DESIGN REVIEW/CERTIFICATE OF APPROPRIATENESS APPLICATION

PROPERTY INFORMATION
Project/Property Address: 788 Taylor Station Road
Project Name/Business Name: Speed Way Towing
Parcel #: 025 003996
Zoning: (see Map) OCT
Acreage: 4.152

PLAN SPECIFICATIONS
Application Type: (check all that apply)
[] Site Plan [] Landscaping [] Building Design [] Demolition [] Other
Project Description: Proposed gravel vehicular storage area and improved paved parking for public use including landscaping, fencing and stormwater management.

Zoning File No. DR-0228-2022

SITE PLAN AND PRELIMINARY LANDSCAPE

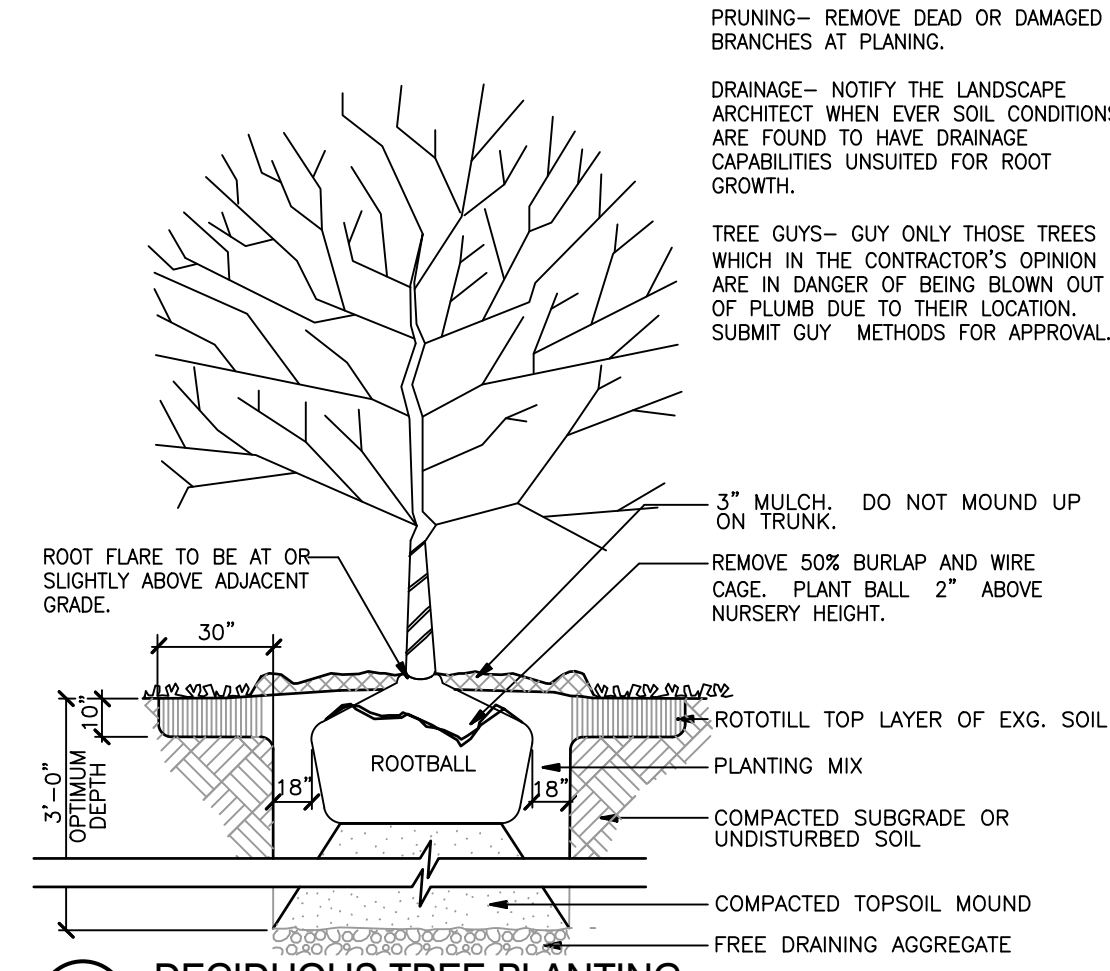
1. Roadway in back parking area exceeds dead end fire department access road of 150 Feet and requires a 120 Foot Hammerhead, 60 foot Y or 96 foot cul de sac in accordance with Figure D103.1.

5. Per Gahanna Code 907.01, driveway approaches are to be in accordance with City of Columbus standard drawings. City of Columbus standard drawing 2202 is non-residential driveway approaches. This driveway approach shall be concrete and comply fully with Columbus standard drawings.

13. Per Gahanna's 2019 Thoroughfare Plan, a right of way width of 80 feet is required along Taylor Station Road. Right-of-way dedication will be required along the property frontages to accommodate that need. Please revise the site plans to reflect that dedication.

18. Please include dimension from side property line to the proposed access drive. Chapter 1163.03 requires a 10' setback. Please revise accordingly.

25. Setbacks for a towing business within OCT zoning are as follows - Building - 75' front, 25' side, 30' rear. Parking - 45' front, 10' side/rear. Please revise labels accordingly.

8/30/22 - Side and rear yard setbacks are not labeled on the site plan.

10. With the 40 foot right of way (from the centerline of Taylor Station Road), the site plan illustrates private improvements within the right of way. Additionally review and abide by any setbacks from the right of way.

Driveway approaches have been modified to meet City of Columbus standard commercial drive.

Eighty (80) foot right of way is provided and identified on the plan.

Access drive dimension from adjacent parcels is provided on the plan.

Setbacks for towing are provided on the plan.

Side and rear setbacks have been added to the plan.

1 DECIDUOUS TREE PLANTING
 NTS DETAIL-FILE

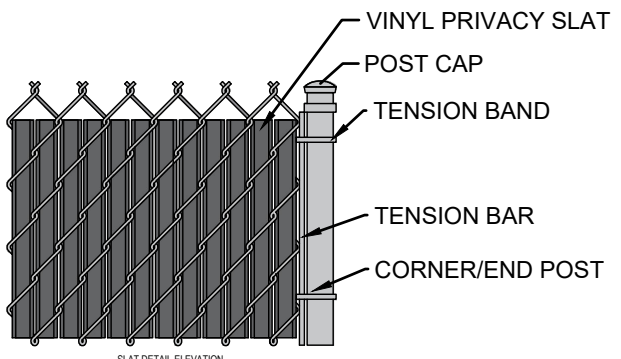
Species list looks appropriate, but be aware that honey locust trees are known to have aggressive surface roots that may impact pavement over time. The planting diagram needs to be updated. At time of planting, pruning should only happen to remove broken or damaged branches. A third of the canopy does not need to be removed at planting. Pruning the trees to 4' clearance is not advised at time of planting. The trees should be in the ground for over a year before clearance pruning takes place.

Mulching at 3" is fine, but mulch should be pulled away from the trunk of the tree (not mounded up on the base). The planting depth should show root flare even with finish grade.

See revised landscaping notes and details.

3 VINYL SLAT PRIVACY CHAIN LINK
 1" = 1'-0" P-CO-SAN-SPEE-02

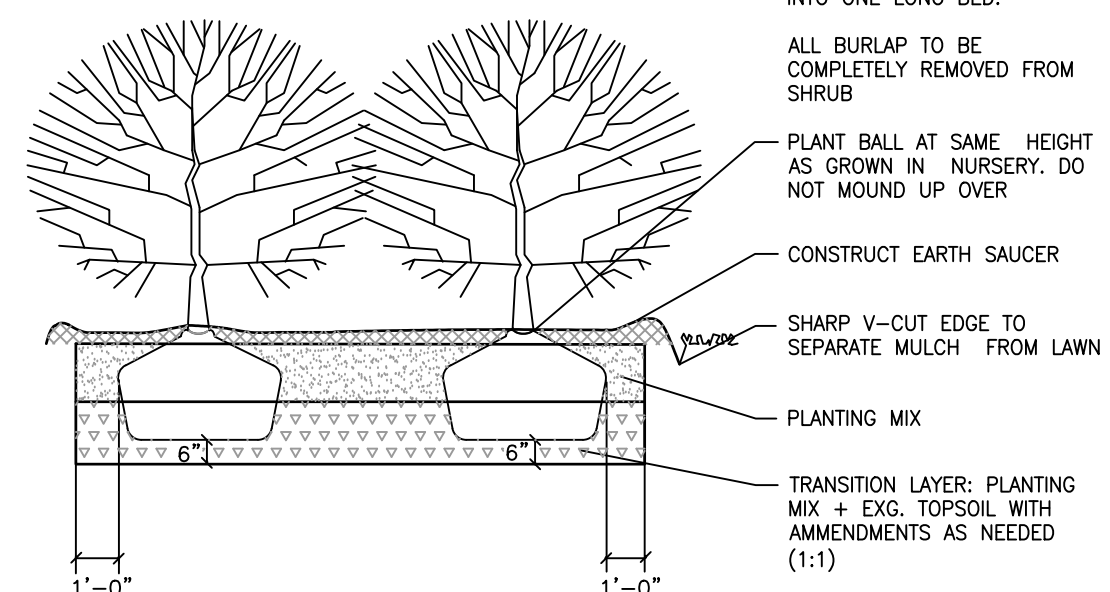
21. It appears fencing is part of the request. Please provide details such as height, location, style, color, etc.

20. It appears fencing is part of the request. Please provide details such as height, location, style, color, etc.

8/30/22 - CH 1171.02(g) does not permit chain link fences in the front yard. The front yard is defined as extending from the right-of-way to the closest wall of the front of the building. The front of the building appears to be about 40' from the right-of-way. Please move the fence to be in line with the front of the building or request a variance. Please provide justification for a variance request.

Proposed fence has been removed from the front yard. Detail of proposed fence has been added to the plan.

LANDSCAPE PLAN

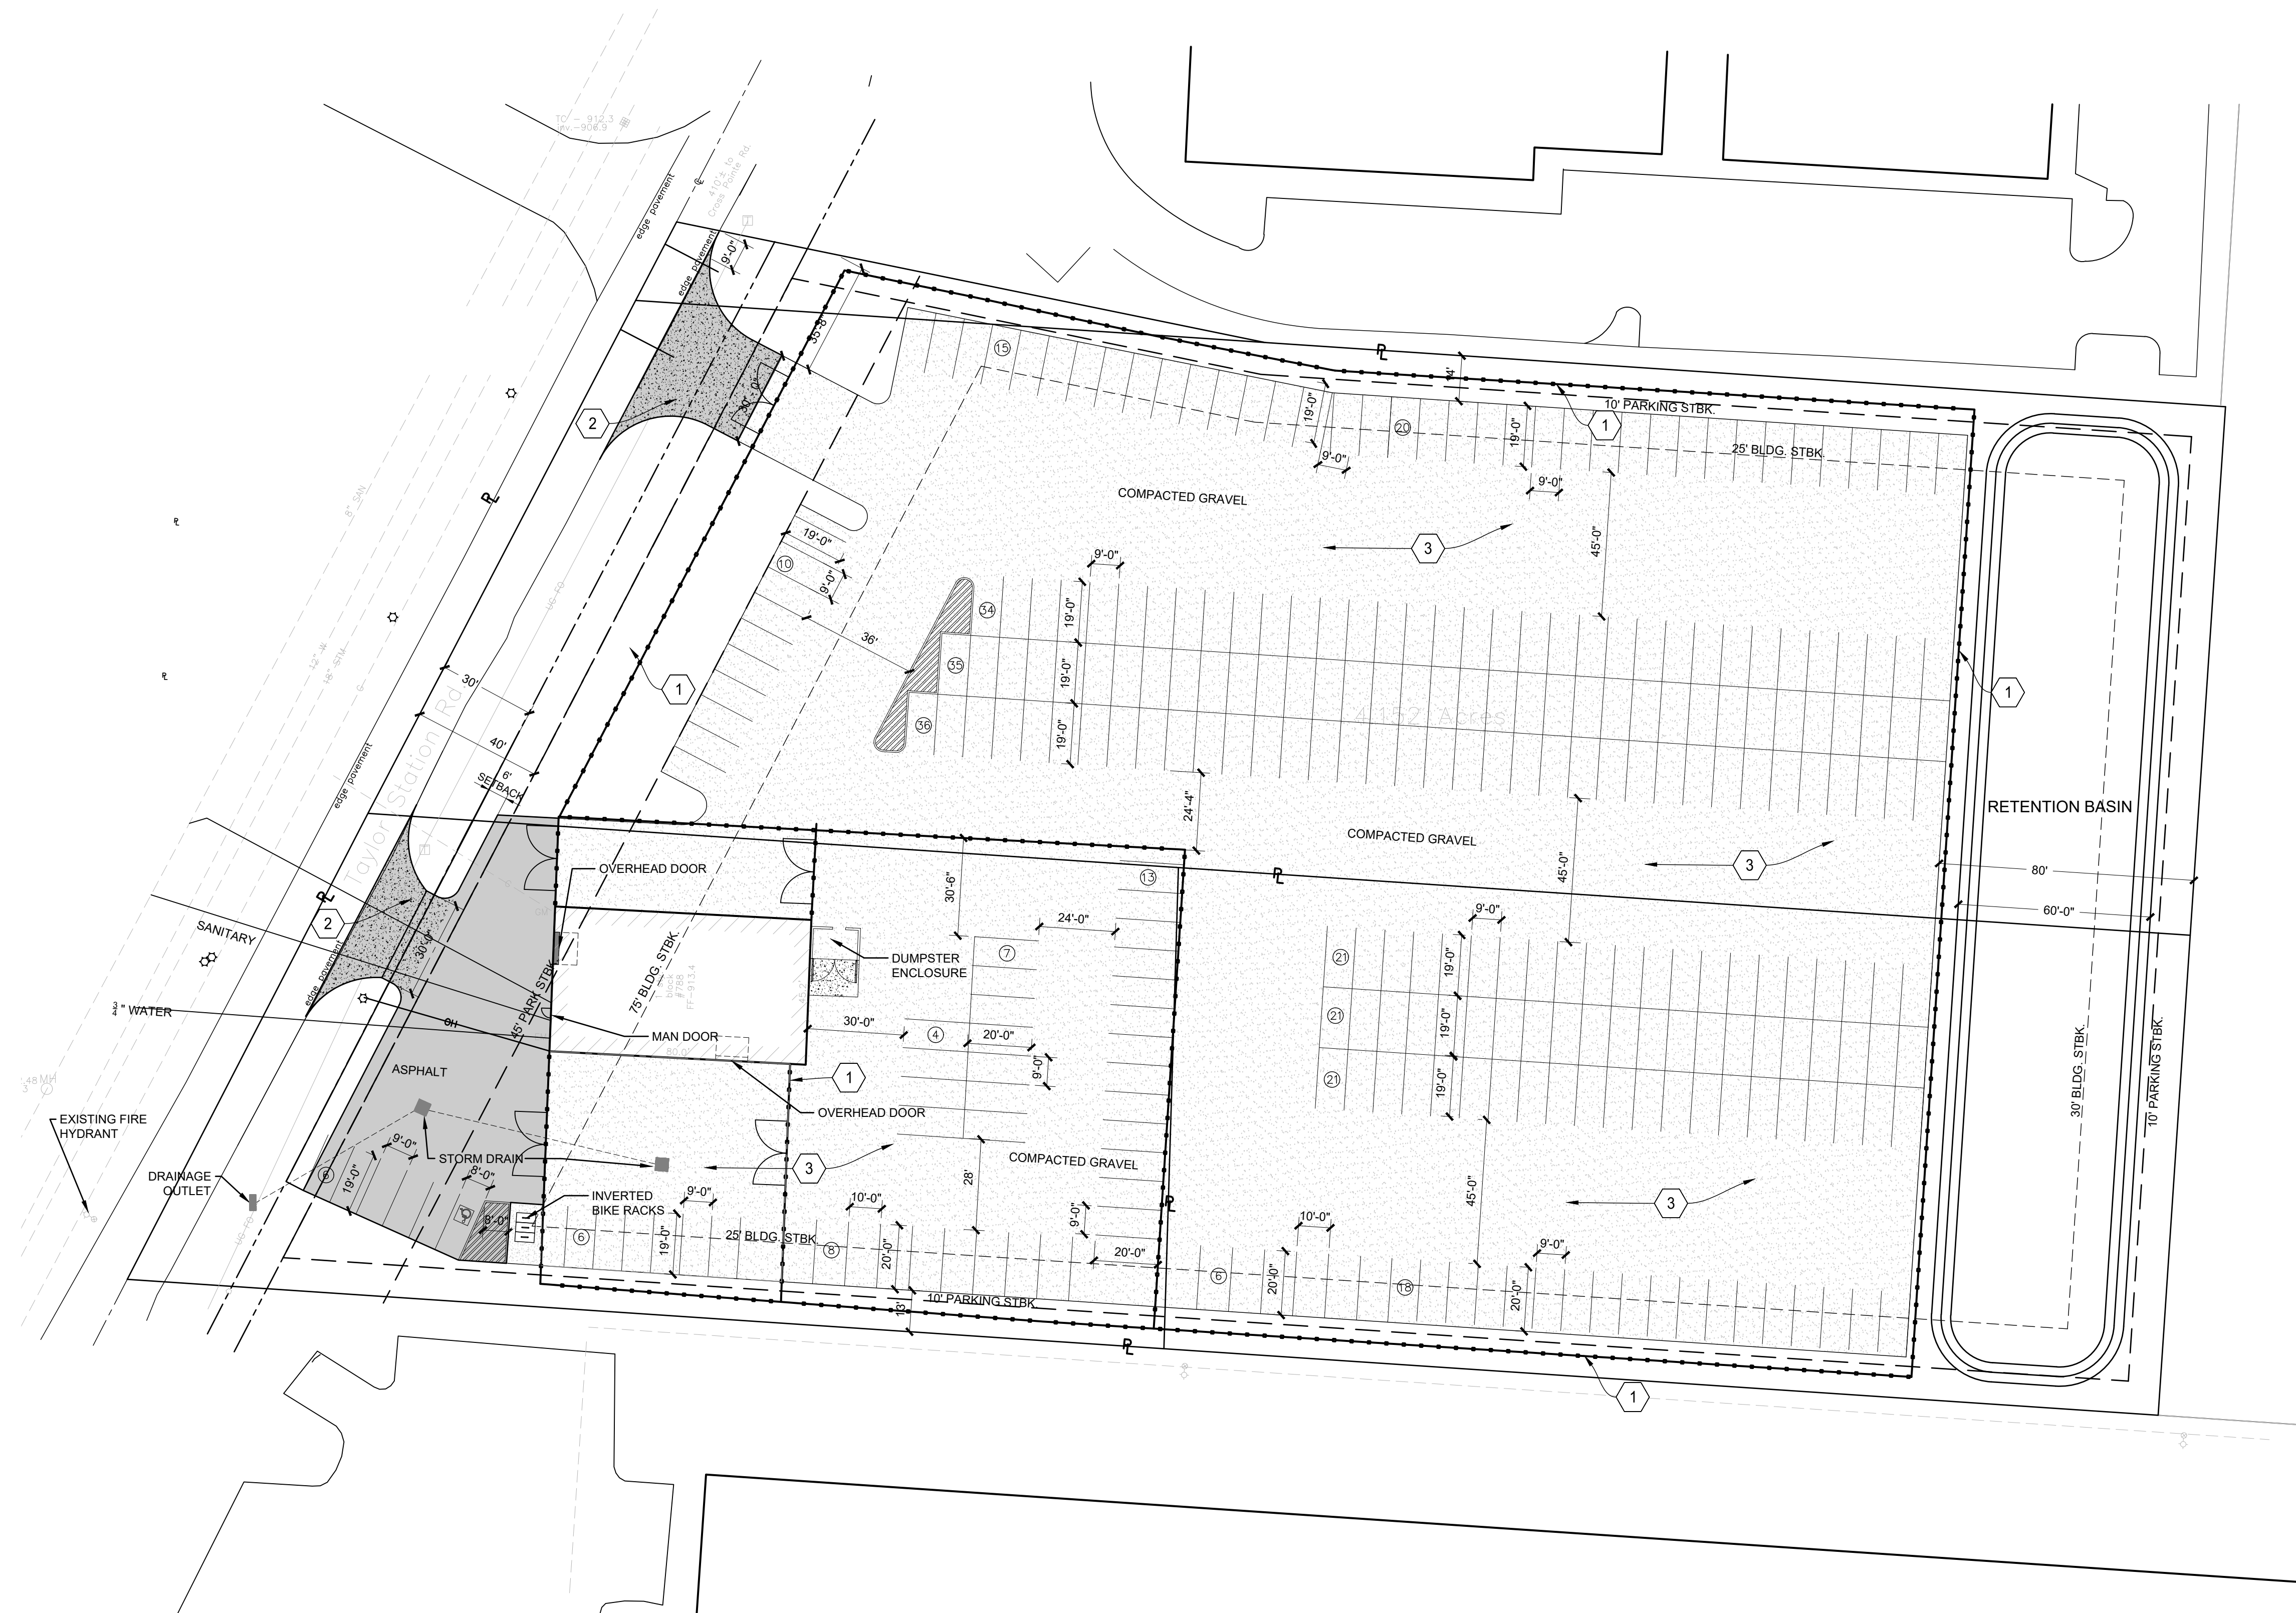
3. This plan is missing important landscape details such as species, size, number required, and planting specifications.

22. Chapter 914 requires tree plantings based on the amount of impervious area. Please review and include plantings meeting this requirement on the landscape plan. Compacted gravel is considered impervious and should be included in calculations.

23. Chapter 1163.08 requires landscaping of parking areas. Please review and include plantings meeting this requirement on the landscape plan. Please be aware that the requirements of Chapter 914 and 1163.08 are separate requirements meaning trees planted for 914 cannot be counted to meet 1163 and vice versa.

5. This plan is missing important landscape details such as species, size, number required, and planting specifications.
6. Street tree plans will need to be reviewed by the Landscape Board. Since no sidewalks are present, I believe large trees spaced at 45 feet are appropriate for this site.

8/30/22 - "Zoning Notes" on the landscape plan indicate 40 trees at 2.5" DBH to be planted for a total of 110.5 tree caliper inches. 40 2.5" DBH equals 100 caliper inches. The "plant schedule" indicates 45 trees to be planted. 45 trees at 2.5" DBH would equal 112.5 tree caliper inches. Please revise accordingly.

8/30/22 - The landscape plan does not include landscaping meeting the requirements of CH 1163.08. Please provide or request a variance. Please provide justification for a variance.

8/30/22 - The landscape plan does not include landscaping meeting the requirements of CH 1163.08. Please provide or request a variance. Please provide justification for a variance.

11/10/22 - As mentioned under other comments, the zoning code defines any area with parked vehicles as parking. Furthermore, the zoning code also classifies, in some instances, vehicular use areas the same as parking. Compliance with landscaping or a variance is required. Staff doesn't have an objection to the variance request to not provide landscaping in the non-public parking areas. Justification for the variance could include that this area is not accessible to the public. Please revise accordingly or request a variance.

Landscaping details have been added to the plan.

See revised landscaping notes and details.
